## **Scheduled Council Meeting - 7 February 2022 Attachments**

7.4.1. TENDER_ _ SUPPLY AND INSTALLATI RX I 1 O ERO EI Z DMJSV 6 PP..	65
7.5. WARRNAMBOOL PLANNING SCHEME AMENDMENT C205WARR CONSIDERATION OF SUBMISSIONS.....	68

7.5.1. COMBINED SUBMISSIONS.....	68
7.5.2. ATTACHMENT 2 FURTHER TECHNICAL REVIEW FTR TEMPLATE AND CRITERIA.....	323
7.5.3. ATTACHMENT 3 OFFICER RESPONSE TO ISSUES RAISED IN SUBMISSIONS.....	326

**Figure 1: 1% AEP flood depths - 2007 North Warrnambool Flood Study**

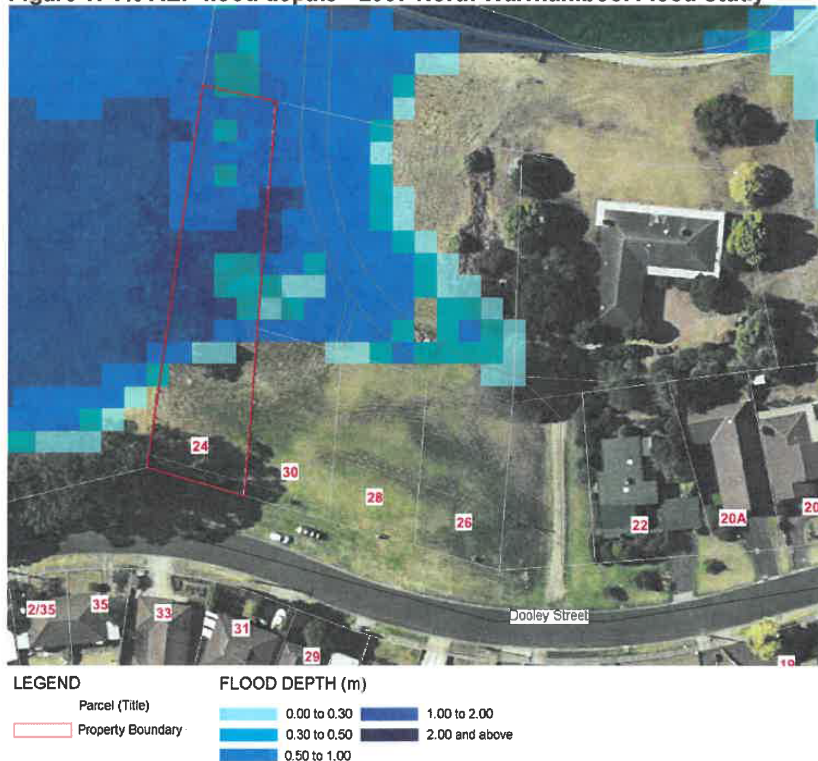
The CMA's estimate of the 1% AEP flood level for this property is 5.55 metres AHD. This level comes from the North Warrnambool Flood Study (2010). During 1% AEP floods a significant portion of the property would be subject to inundation by the Merri River as indicated by the blue shading on Figure 1.

The CMA supported the subdivision to create this lot on the provision that building envelopes were created outside the estimated 1% AEP flood extent. Photos and the description provided in the application when compared to contour data based from 2007 LiDAR (as shown in Figure 3), indicate that levels have been altered and that unclean fill has at some stage been placed on this property without consultation with the CMA. This portion of the property is covered by Urban Floodway Zoning (UFZ) - see Figure 2. It's our understanding that removal or addition of fill in the UFZ would trigger a requirement for a planning permit. UFZ also does not provide for development of a dwelling. The UFZ would need to be formally removed through a deletion amendment before construction of a dwelling within this area could be considered.

**Figure 1 – Locations in north Warrnambool where flood risk mapping can be removed from properties due to negligible flood risk.** Note: This image only highlights a few examples, many more can be seen in this image that are not circles.

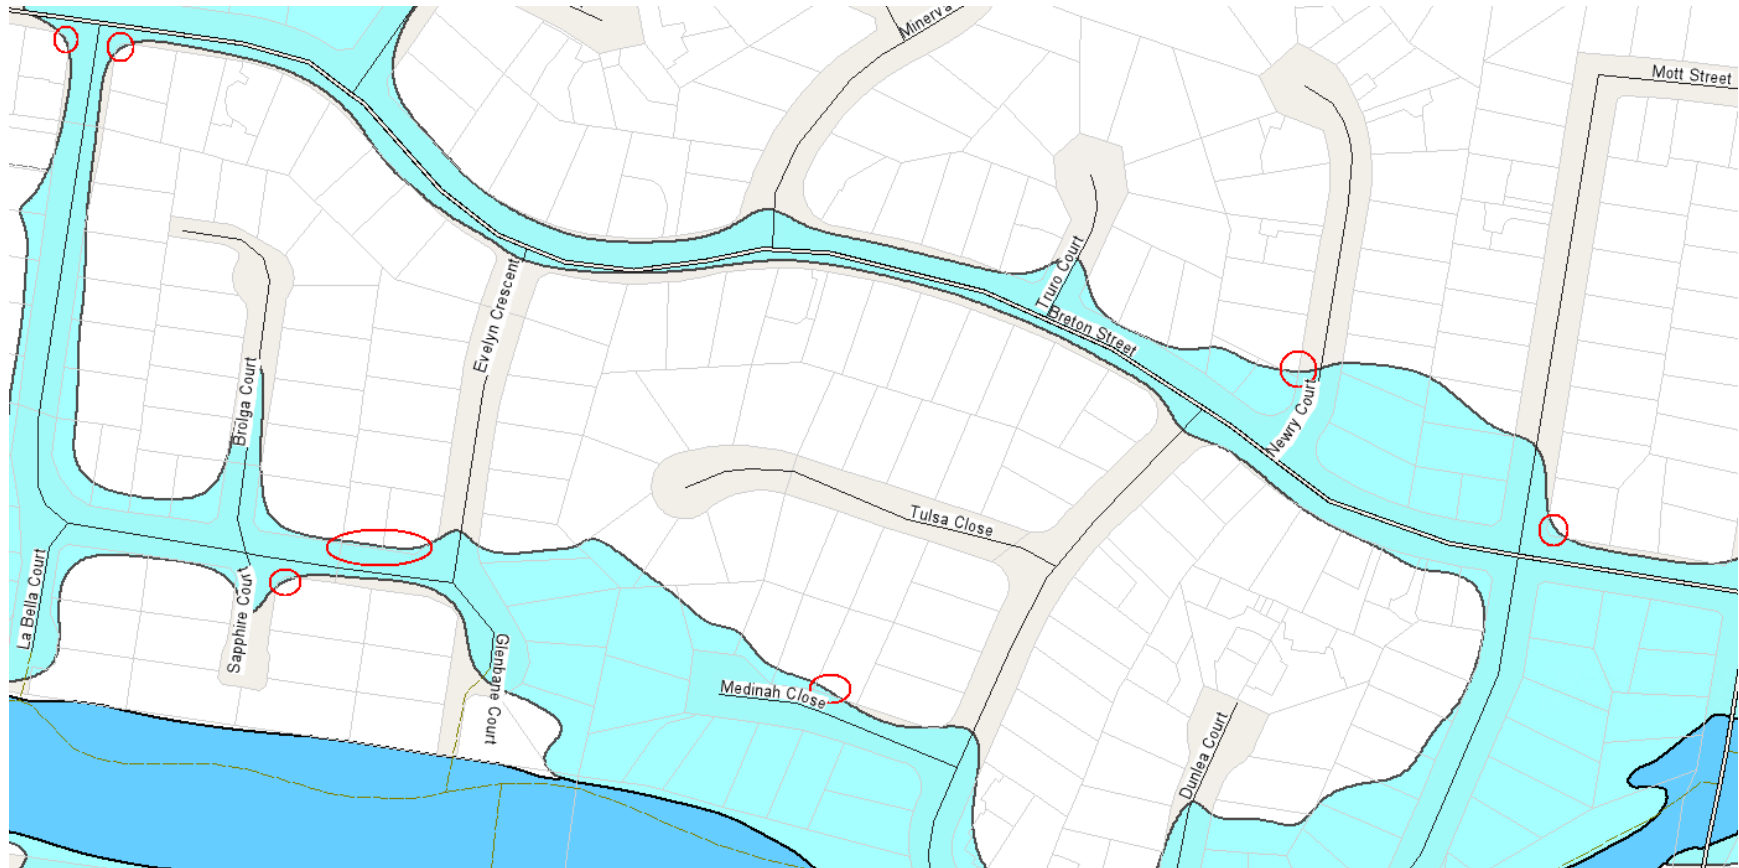
8. Smoothing and fine tuning of the revised overlay shapes was undertaken with the assistance of the CMA to:
  - a. remove unwarranted permit application triggers associated with minor impingement of overlays across property boundaries (see figure 1 below); and
  - b. filter out flood 'islands' to ensure development decisions account for risks posed by loss of access/egress to properties during large floods; and.
  - c. smooth jagged edges of raw flood control maps stemming from gridded data outputs.

This approach is consistent with the GHCMAs flood control delineation guideline. However, close inspection of the exhibited mapping indicates further refinement is warranted. See Figure 1 for an example of locations where flood risk can be removed for planning purposes.

**The CMA recommends further refinement of the planning control boundaries in collaboration with the CMA prior to final adoption.**
